sixth floor plan _ proposed

THE BARTLETT SCHOOL OF THE BUILT ENVIRONMENT
UCL
22 Gordon Street, London. WC1H 0QB

seventh floor plan _ proposed

roof plan _ proposed

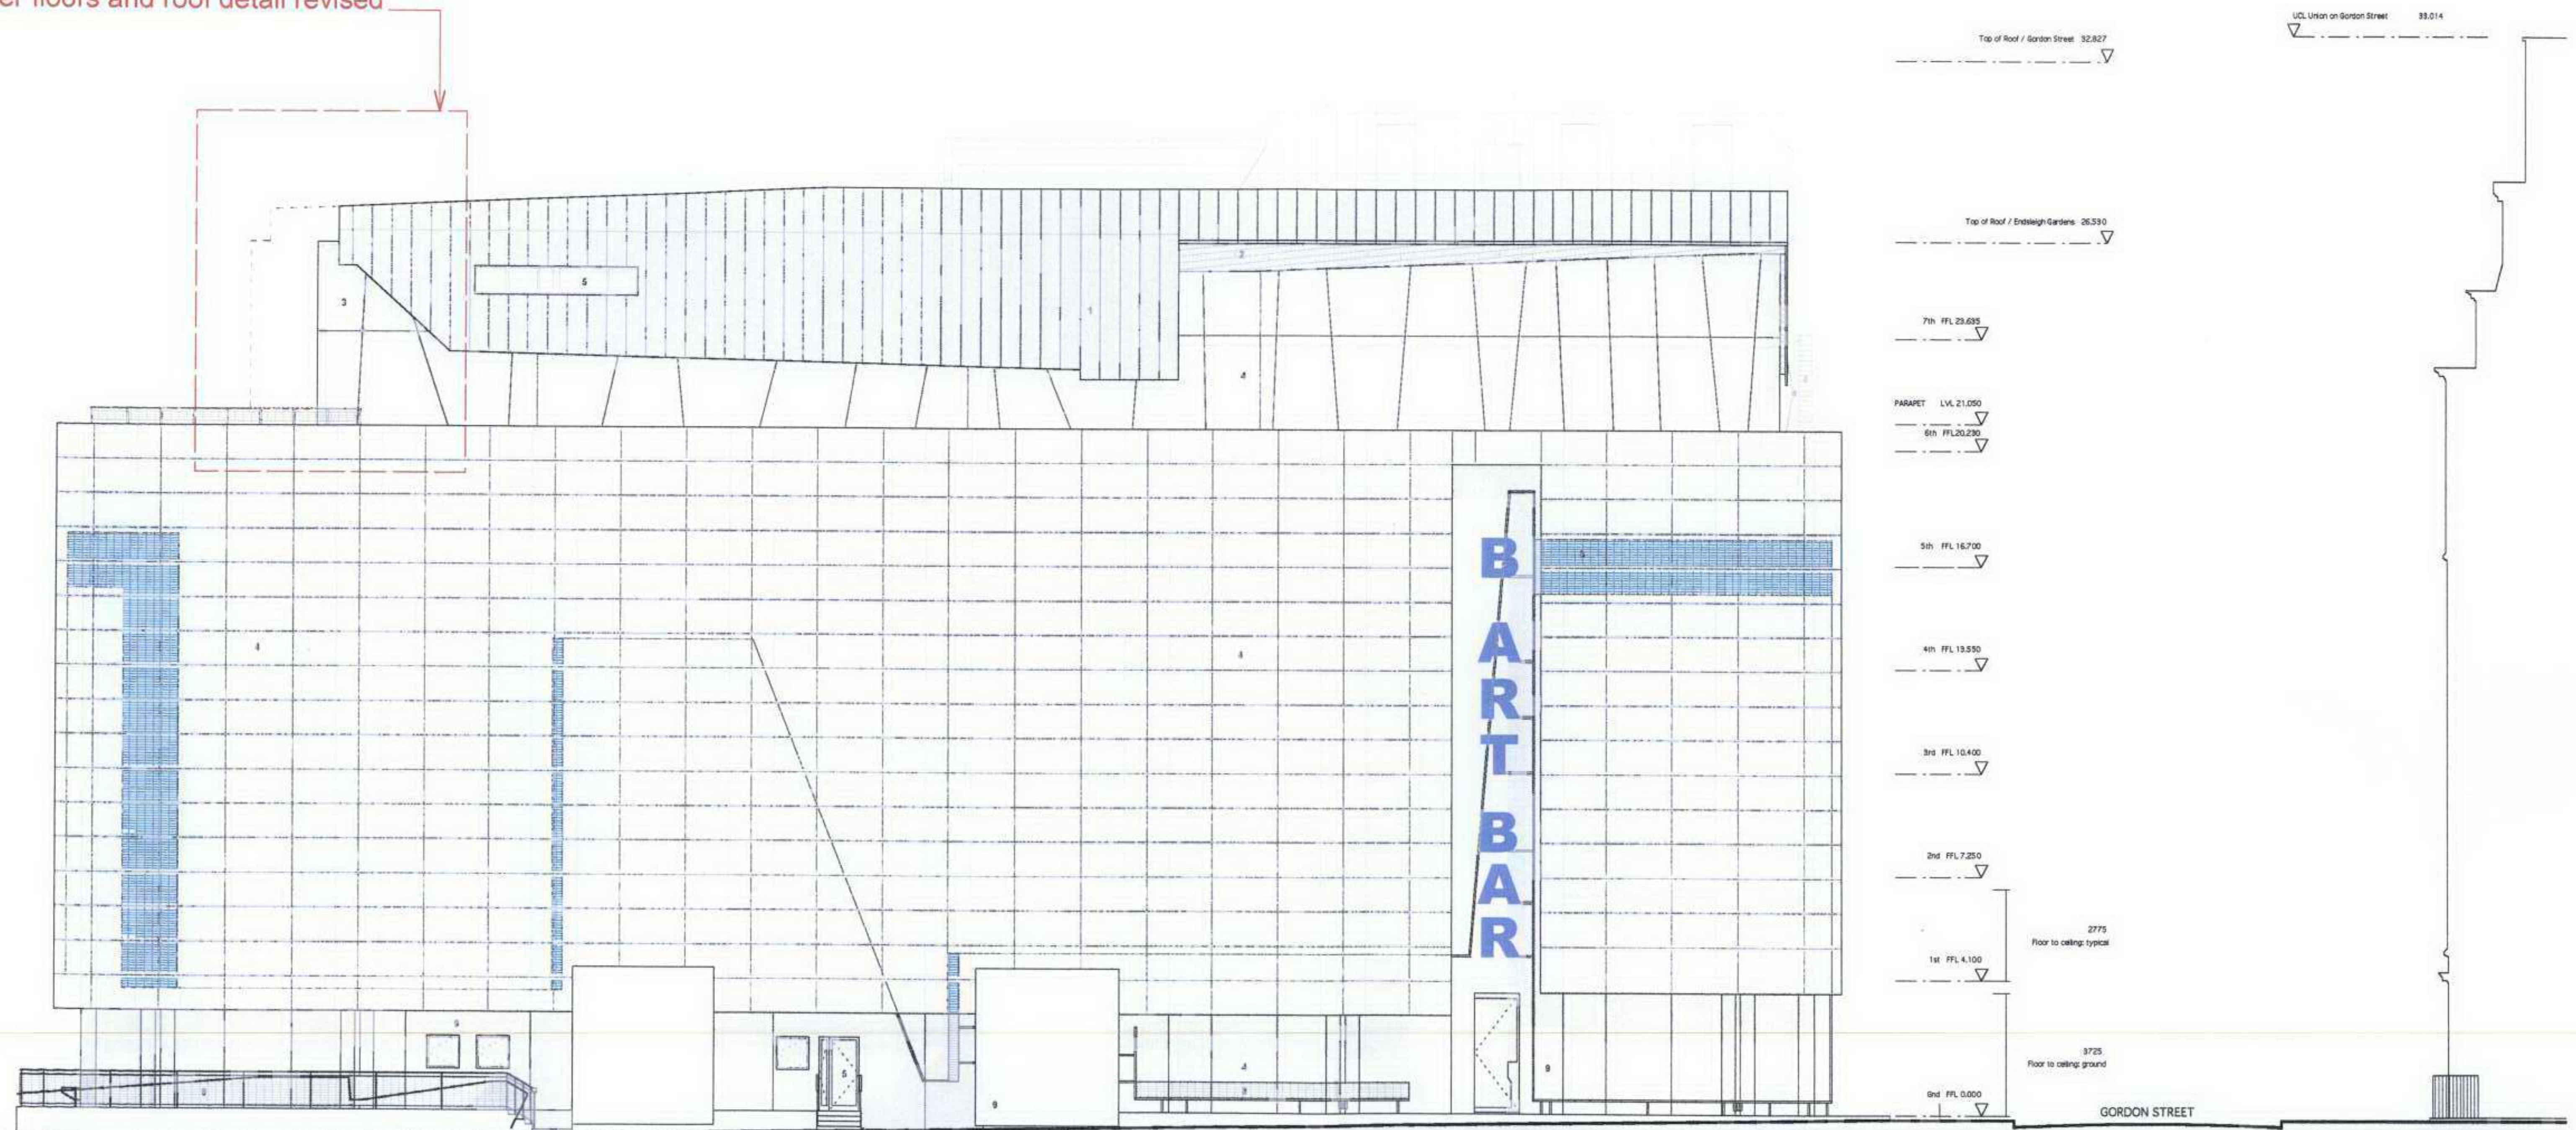
Upper floors and roof detail revised

- Revision 05 - 04.05.08
- Eastern edge of roof and glass facade at 6th & 8th floor set back 2m in response to comments by English Heritage

GORDON STREET ELEVATION

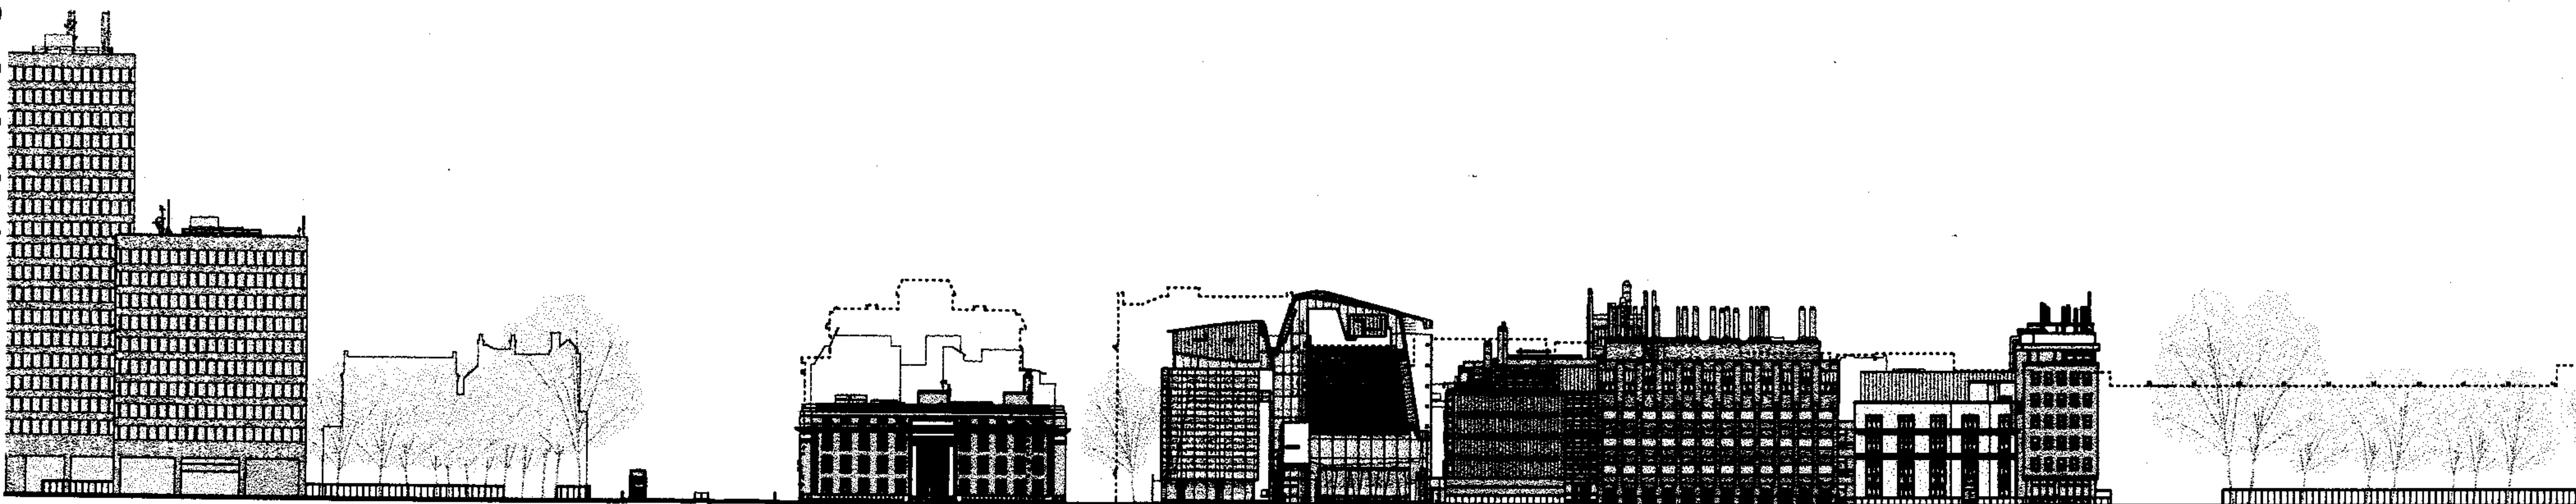
- Revision 01 - 04.08.04
- Plant Room level removed
 - South and East facade revised
- Revision 02 - 19.08.04
- South and East facade revised
- Revision 03 - 14.10.05
- South and East facade revised
- Revision 04 - 04.08.06
- Eastern edge of roof and glass facade at 6th & 8th floor not built. Silver mesh panel at cornice level returns to south side and mesh at 1st floor balcony level returns back to facade. Changes are in response to comments by English Heritage.
